## WESTERN MINING ACTION PROJECT

**RE:**                   **OBJECTION to the**  
Resolution Copper Project  
Final Environmental Impact Statement (“FEIS”) and  
Draft Record of Decision (“Draft ROD” or “DROD”)

Responsible Official: Neil Bosworth, Forest Supervisor  
Tonto National Forest

**Figure 2.2.2-4. Overview of the mining process at full operation**

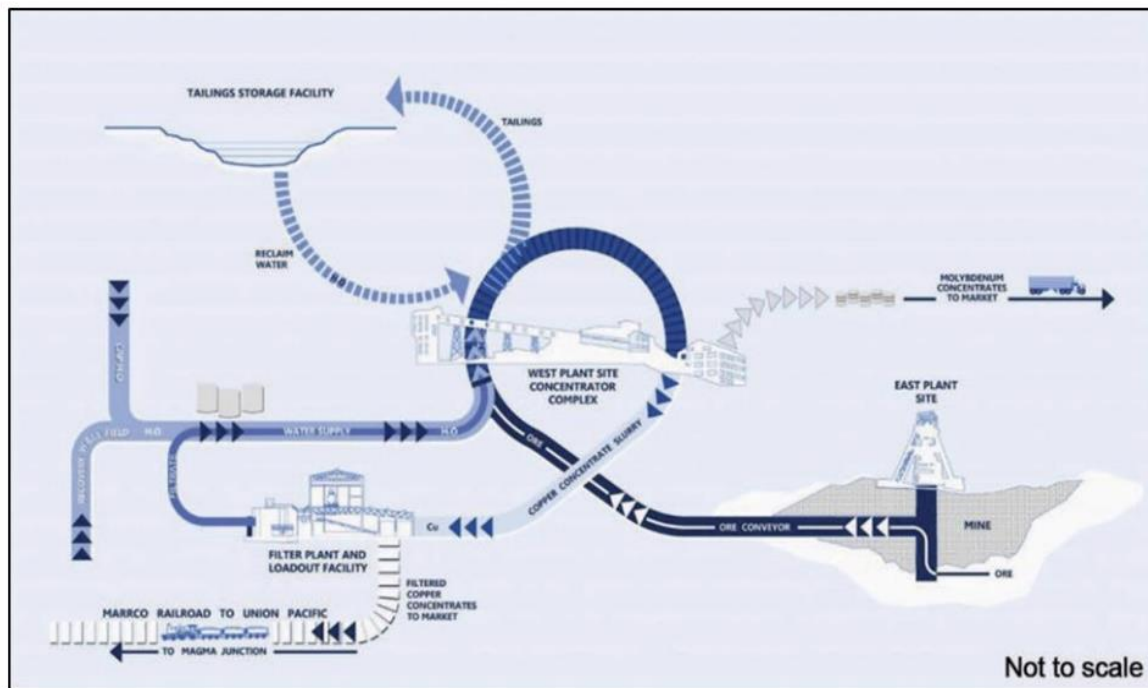
The massive water footprint of the Project can be generally attributed to Resolution Copper's plans to (a) pump raw groundwater from the Desert Wellfield located along or MARRCO Corridor in the East Salt River Valley (544,858 AF, *see, e.g.*, FEIS at 443, Figure 3.7.1-7), which will be used throughout the Mine Project, including for processing ore at the West Plant Site, delivering copper concentrate in the form of a slurry to the filter plant and load out facility in the San Tan Valley, and to transport tailings as a slurry from the West Plant Site to the tailings facility at Skunk Camp under preferred Alternative 6; (b) continue massive mine dewatering activities at the Mine itself at Oak Flat and the East Plant Site to keep its tunnels, adits, shafts, and other underground infrastructure free of water—water that will then be fully consumed in the mining operations (at least 87,000 AF according to the FEIS); and (c) maintain a massive tailings facility that will eventually total 4,900 acres in size and will require the continued capture and diversion of precipitation and stormwater which, over time, will be lost via evaporation and seepage, potentially in perpetuity.

*Modified Excerpt of Figure 3.0-1a  
from the General Plan of Operations, Resolution Copper Mining  
(red arrow inserted to indicate distance)*

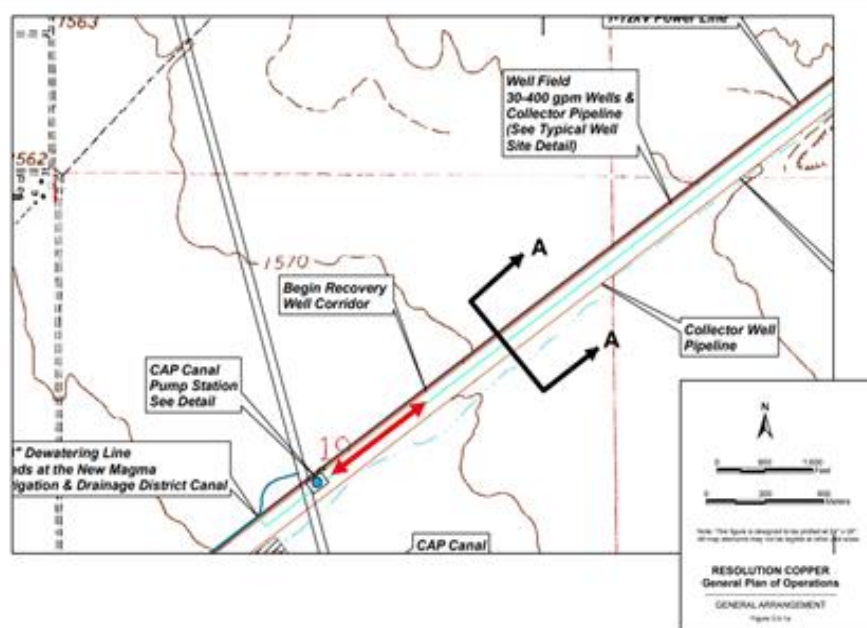
Based upon estimates of groundwater declines in the Desert Wellfield area, in a range of 228 feet, FEIS at 444 & Figure 3.7.1-2, the Forest Service acknowledges the potential for

Figure 2.2.2-5. Predicted mining subsidence areas and the East Plant Site area

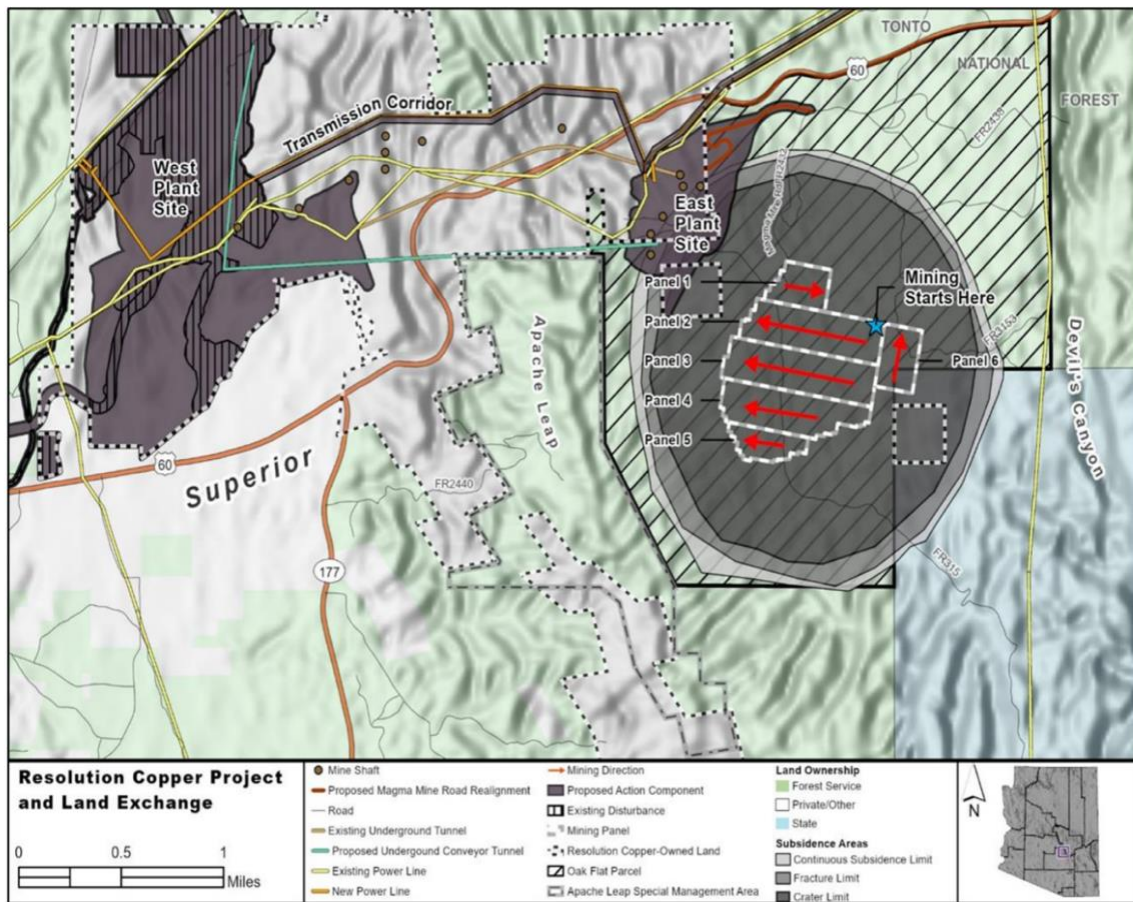
The Mine will also directly impact State Trust Land adjacent to and within the subsidence area at Oak Flat. FEIS at 65, Figure 2.2.2-5 (*shown on following page*). The State Trust Lands that will be subsumed by (swallowed up) by the Mine subsidence at Oak Flat, will be lost from the State Land Trust forever as will the potential of these State Trust Lands to generate revenue for the State Trust Fund. None of these socioeconomic impacts are disclosed, quantified, or evaluated in the FEIS. The FEIS only notes the Forest Service's "assumption" that the State Trust lands in the subsidence zone "would be sold rather than leased." FEIS at 318.
